Item Name: Heli-Access-Step LH

Reference: ECN13-627 - *Re-work*

DART SERVICE INSTRUCTION

TO AMEND INSTALLATION INSTRUCTIONS IIN-D119-675 REV. B AND
INSTRUCTIONS FOR CONTINUED AIRWORTHINESS ICA-D119-675 REV. 2
REF. FAA STC SR00948SE & EASA STC EASA.IM.R.S.01458

FIGURE 1 - D119-675-011/-012 HELI-ACCESS-STEP™

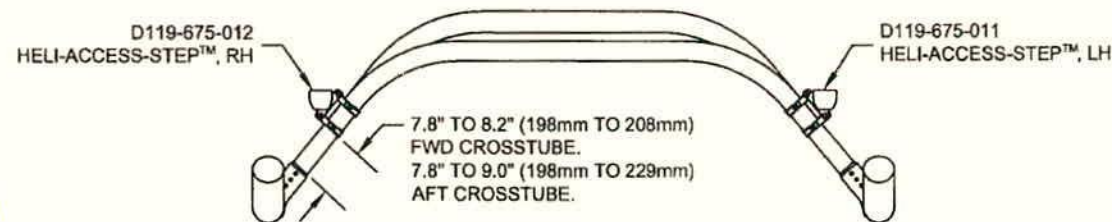
3.5 Find the appropriate step height by locating the step/clamp as shown in View A-A. Locate the forward D3041-1/-3 Clamp 7.8"- 10.4" above the crosstube cuff. Locate the aft D3041-1 Clamp 7.8"-11.6" above the crosstube cuff. The distances given are from the crosstube cuff to the bottom-most clamp.

REFER TO IIN-D119-675 REV. B PAGE 5. OR ICA-D119-675 REV. 2 PAGE 21. UPDATE AS SHOWN BELOW:

IS:
SECTION B-B
 FWD CROSSTUBE,
 VIEW ROTATED

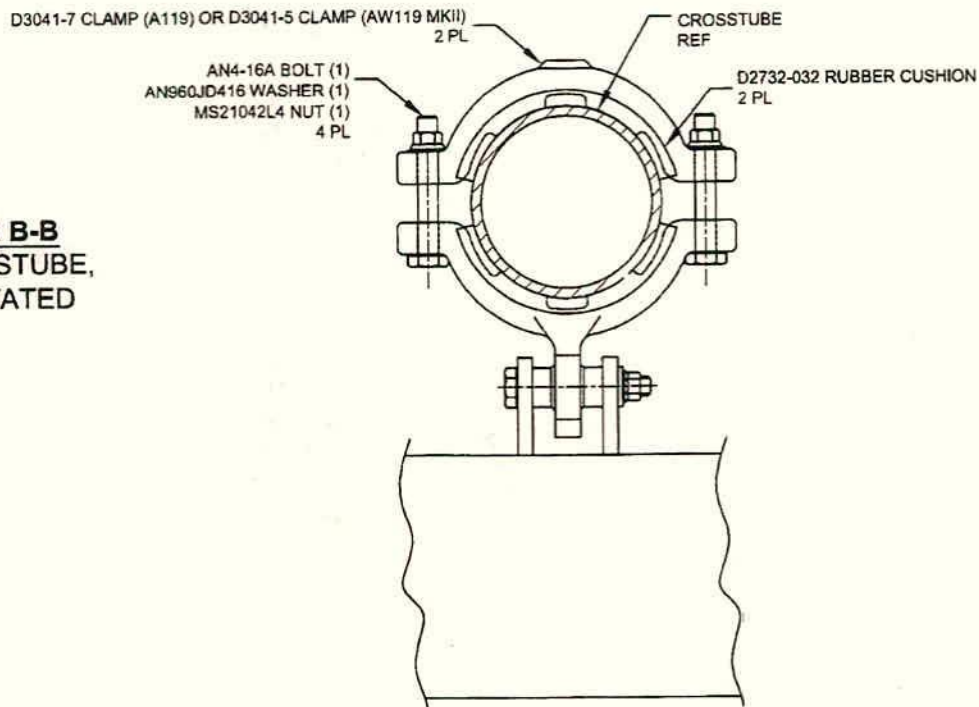
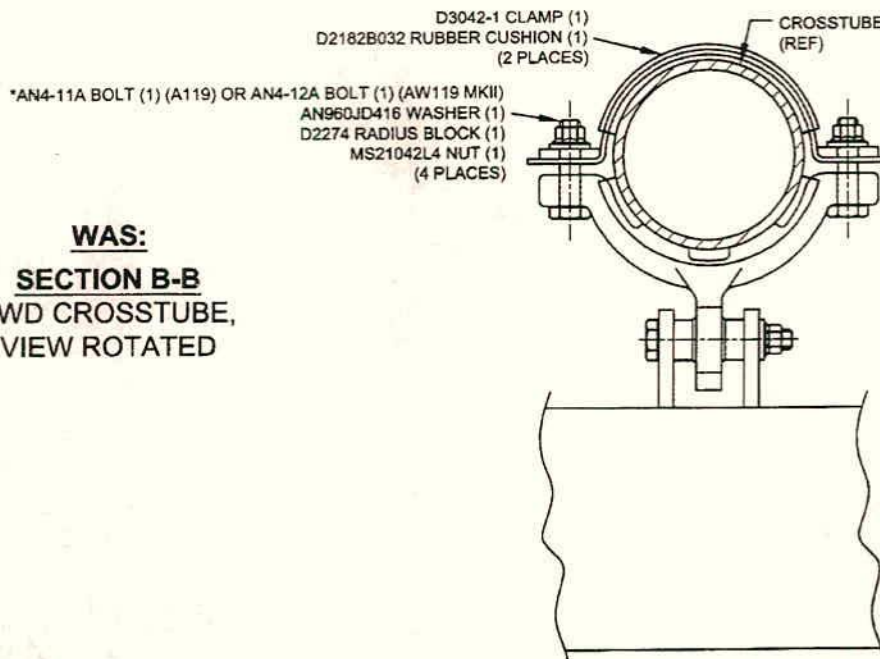
- 2.1 The DSI 9647-011 Clamp Replacement Kit can be procured from Dart. One kit upgrades one step.
- 2.2 Remove and discard the D3042-1 Clamps, D2182B032 Rubber Cushions and hardware. Replace with the D3041-5/-7 Clamps, D2732-032 Rubber Cushions and hardware as shown in Section B-B and C-C of this Service Instruction.
- 2.3 Tighten clamp bolts. Do not exceed torque of 60 in-lb (6.8 nm) on the nuts.
CAUTION: Over-torquing the nuts could lead to structural damage of the clamps.
- 2.4 Amend weight and balance per section 4.0 of this Service Instruction.

3.4 Install the D2732-032 Rubber Cushions under the D3041-1/-3/-5/-7 Clamps (see Sections B-B and C-C (of this DSI)).
